**SAN LORENZO VALLEY WATER DISTRICT
CROSS COUNTRY PIPELINE CONSTRUCTABILITY
PEER REVIEW OF FREYER & LAURETA STUDY AND MEMO**

**Peer Review of March 2022 Study and
Draft Supplemental Evaluation Dated April 6, 2022**

24 NOVEMBER 2022
PROJECT NO. 12196

PRELIMINARY ACCESS AND CONSTRAINT MAP 5-MILE AND PEAVINE WATER LINES San Lorenzo Valley Water District

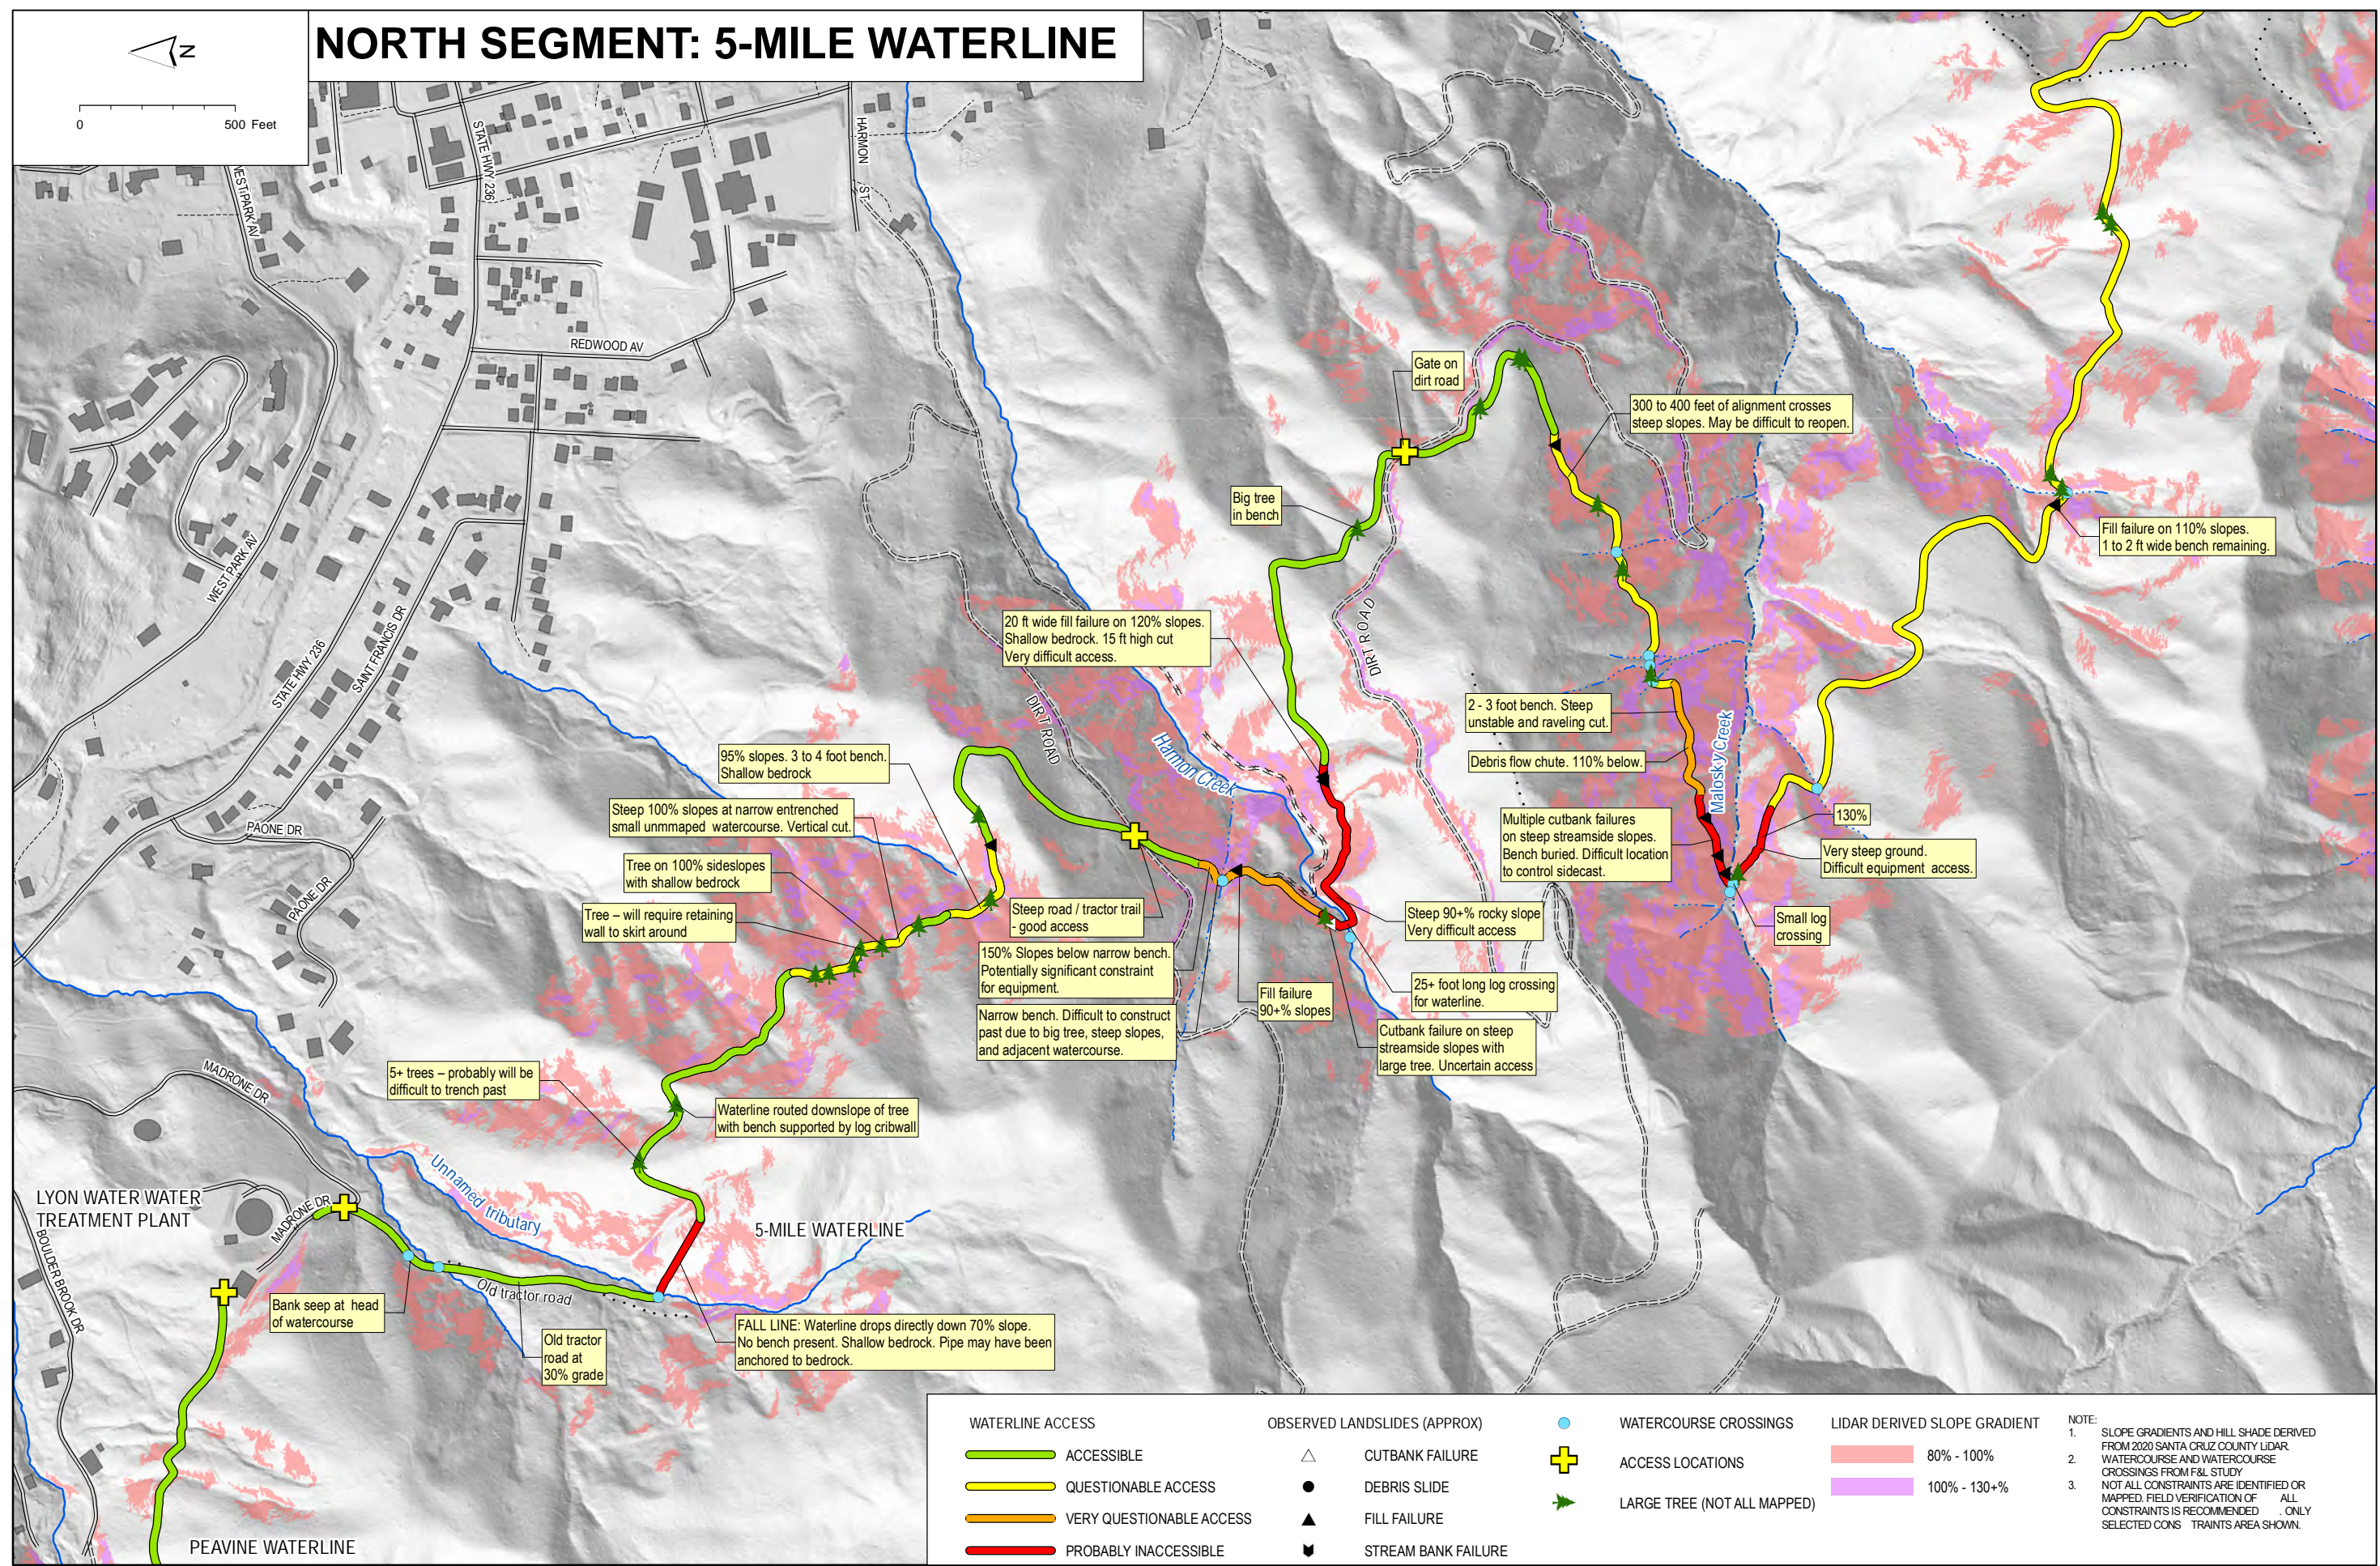
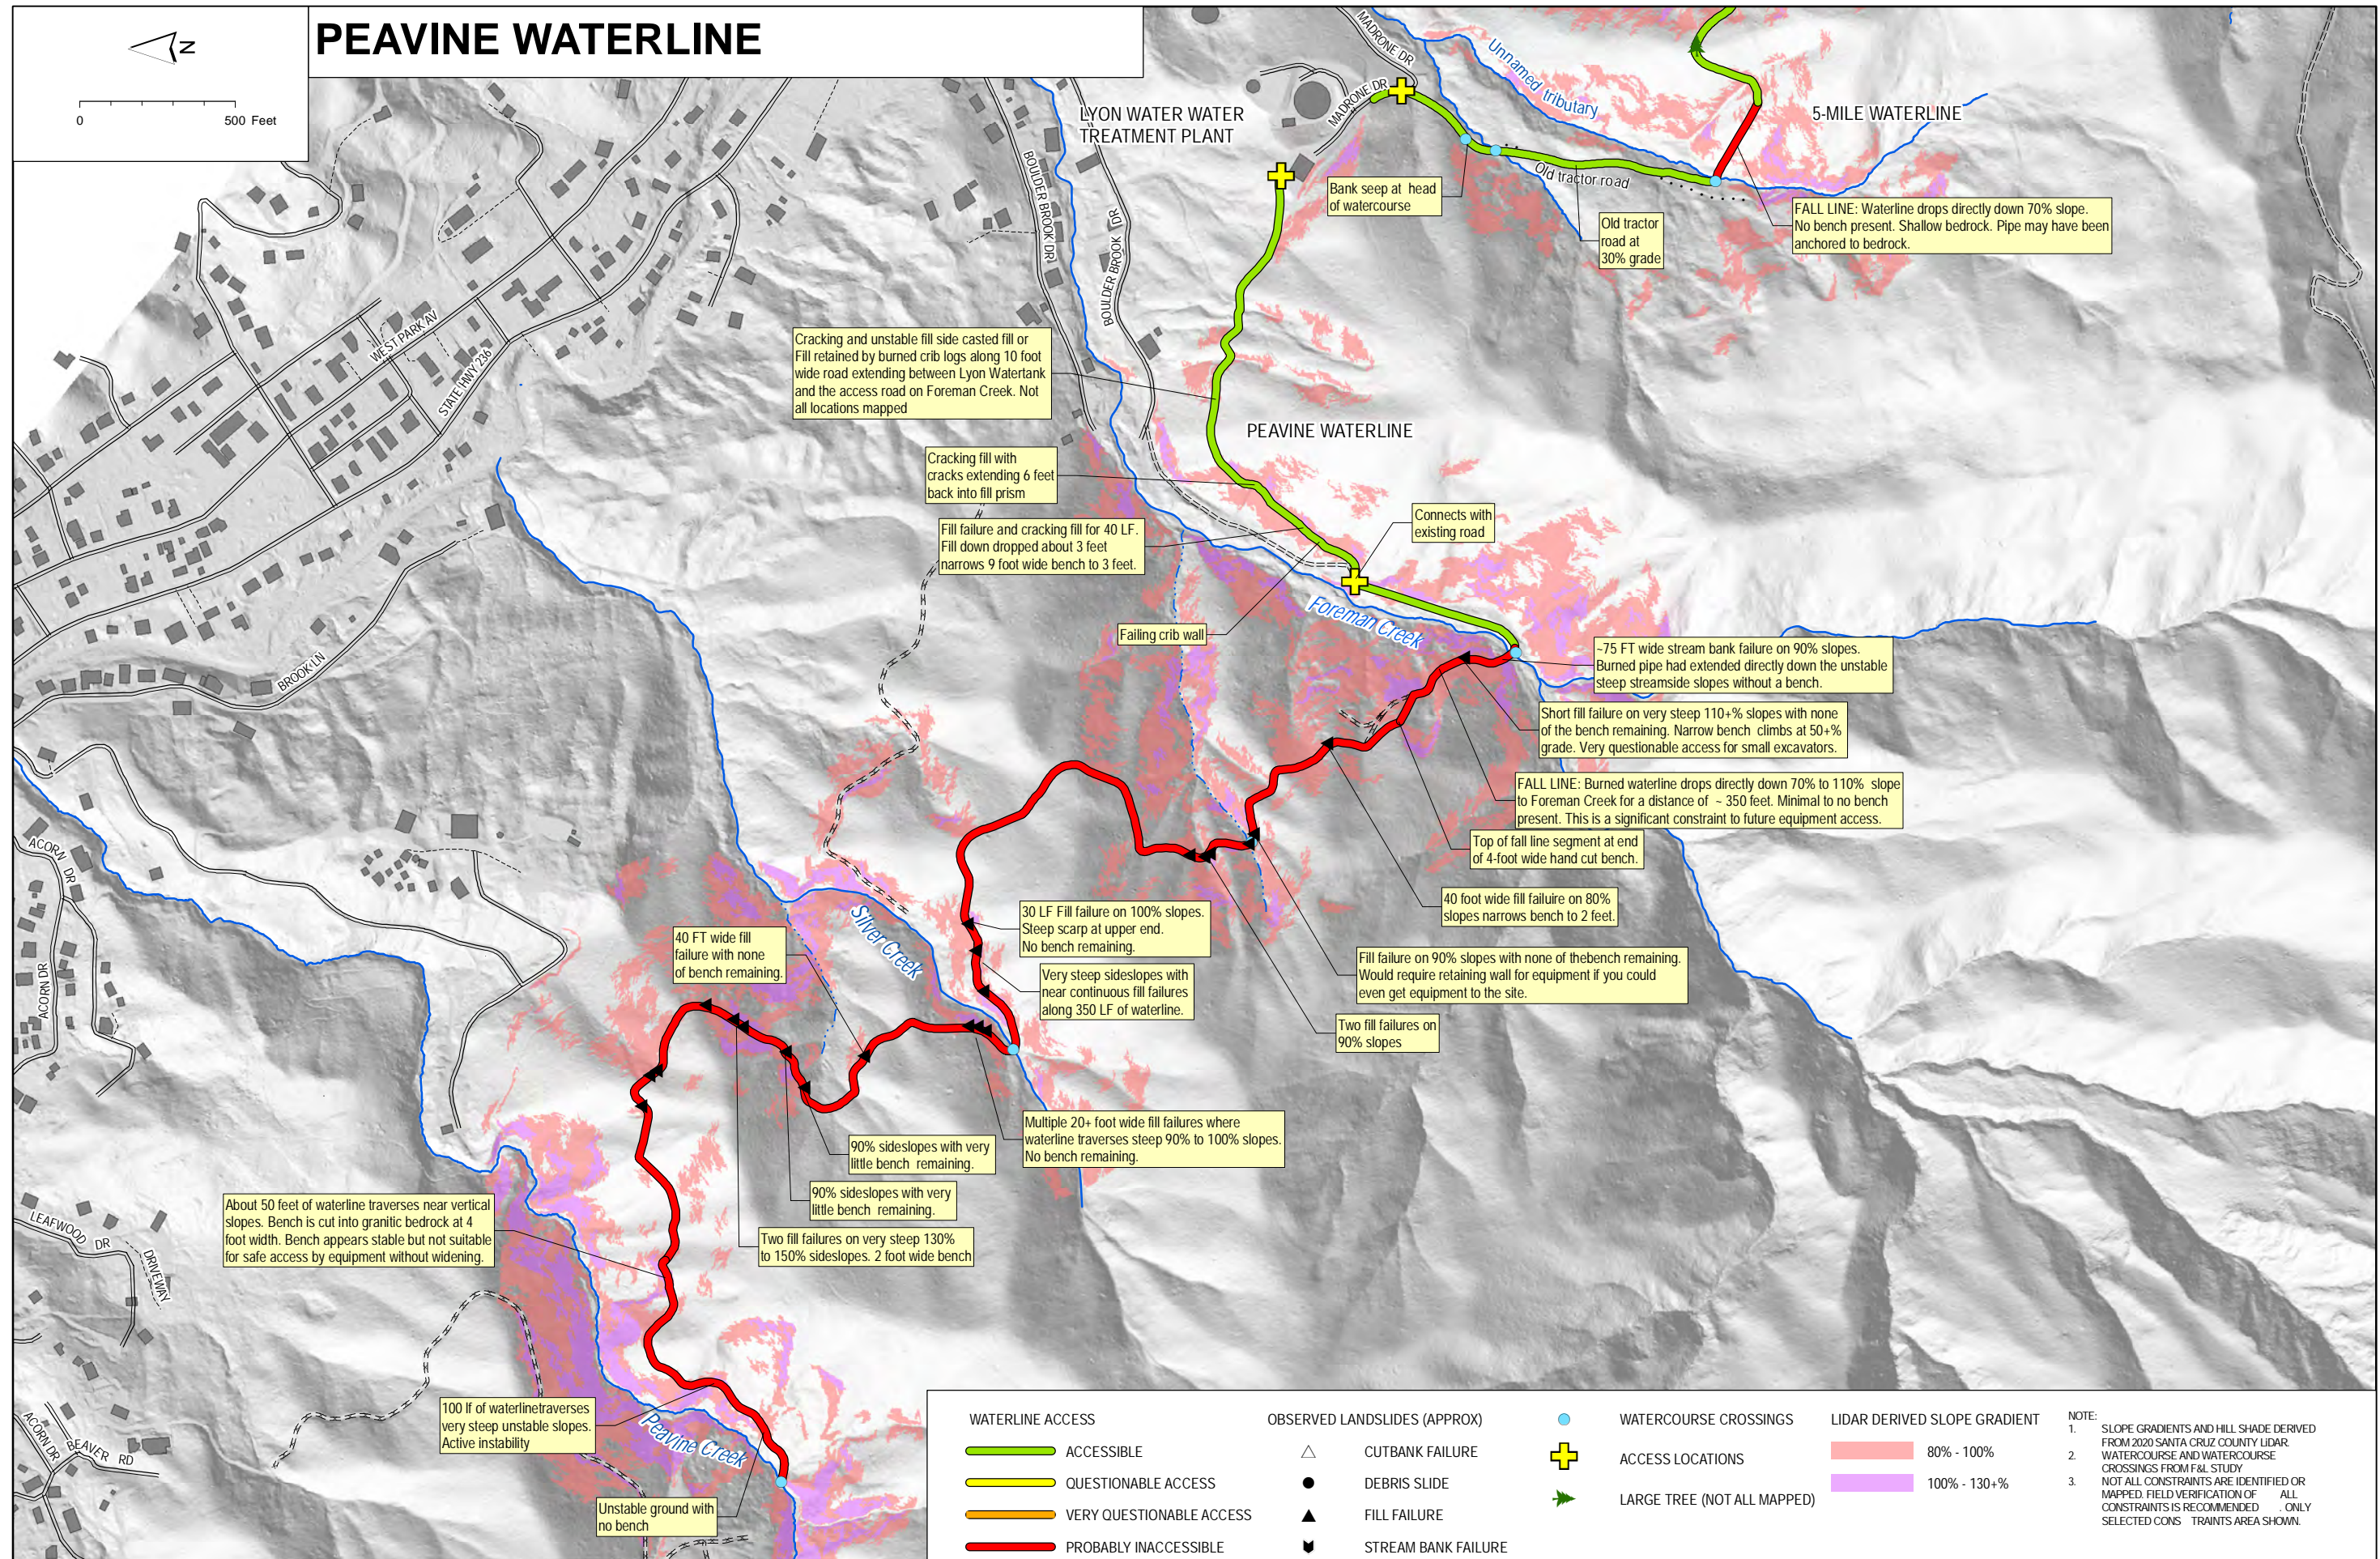
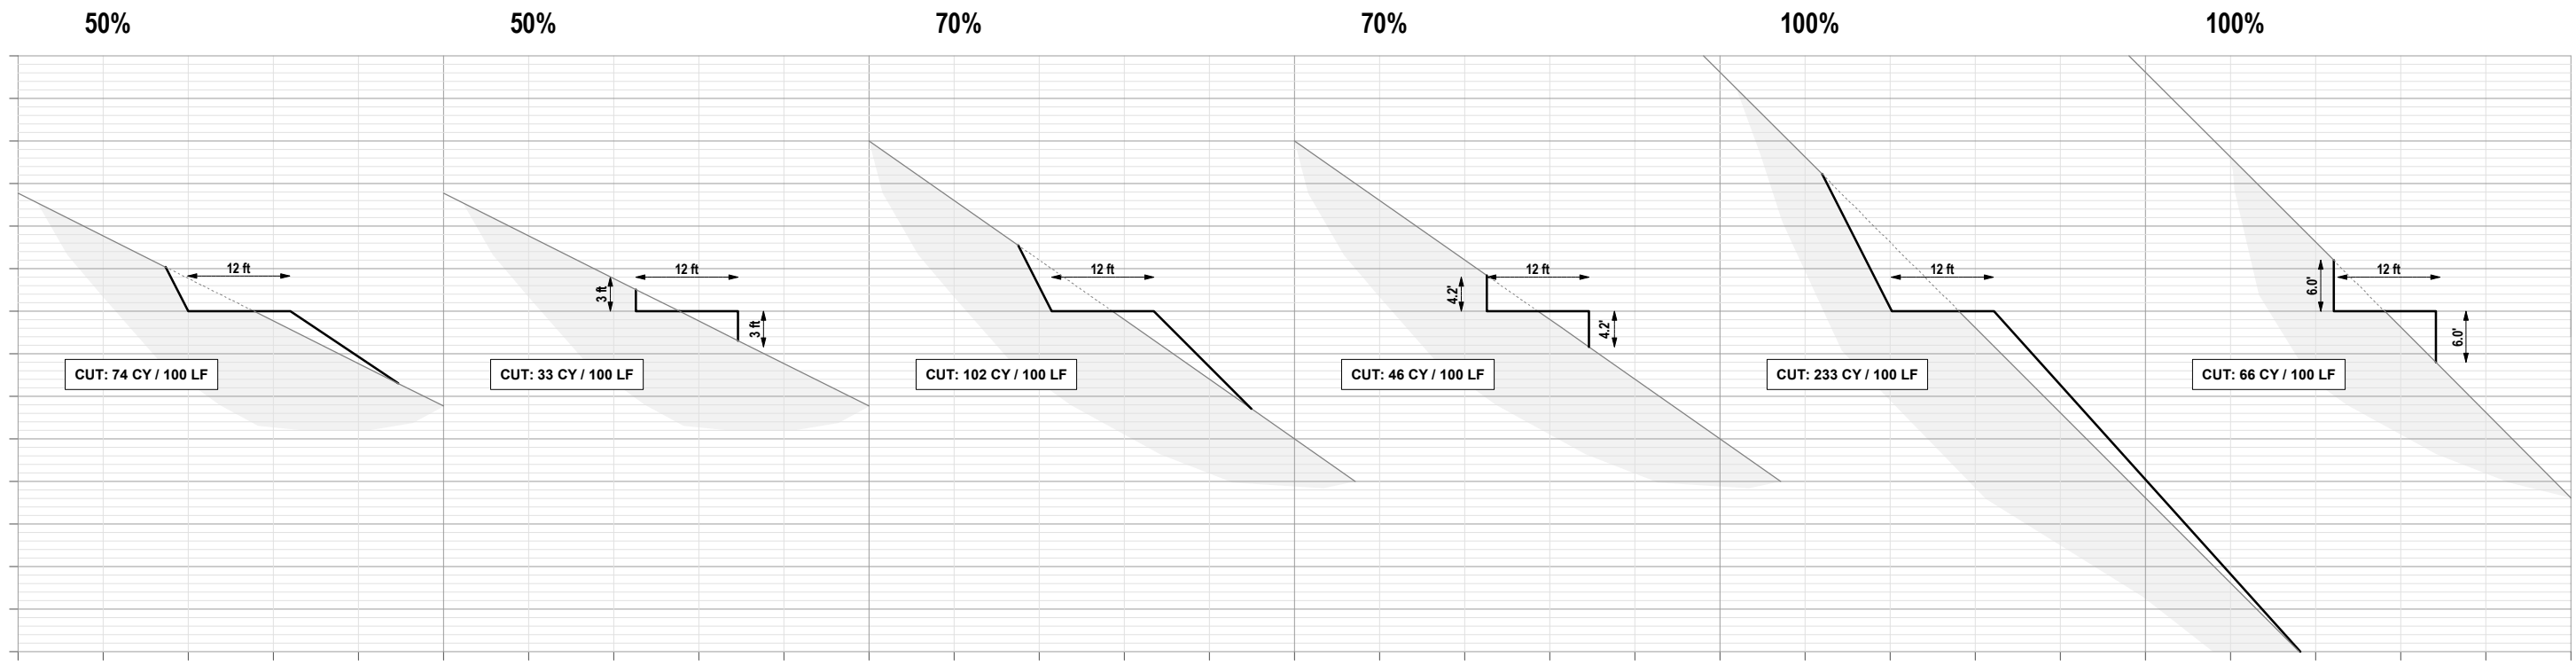
1. Further review and analysis to identify, map, and characterize access locations and choke points. A preliminary access and constraint map is shown in Figure 4A, B C of our report, but that map is not comprehensive. A complete understanding of physical constraints and their associated limitation on construction and access is essential prior to deciding on the design bench width, selection of the best alternative, and associated budget for construction.

HKA finds that good access to the waterline is restricted to about 7 locations where existing roads cross the waterline (See Figure 4 in Appendix A). Three of these locations are at old logging road and tractor road crossings that appear to cross private property. It is unknown if the District has an easement to use these roads. In addition, one of the three access points is an old overgrown tractor road, of which the condition and suitability of the entire length has not been assessed and where certainty of equipment access is unknown. There may be the potential to access the waterline from above by constructing new access along ridgelines, though again, additional review will be required to evaluate this. Outside of these locations, the waterline cannot be reasonably accessed without new road or trail construction across steep sideslopes. Access by helicopter may be possible in some areas.

1. Further review and analysis to identify, map, and characterize access locations and choke points. A preliminary access and constraint map is shown in Figure 4A, B C in this report, but that map is not comprehensive. A complete understanding of physical constraints and their associated limitation on construction and access is essential prior to deciding on the design bench width, selection of the best alternative, and associated budget for construction.
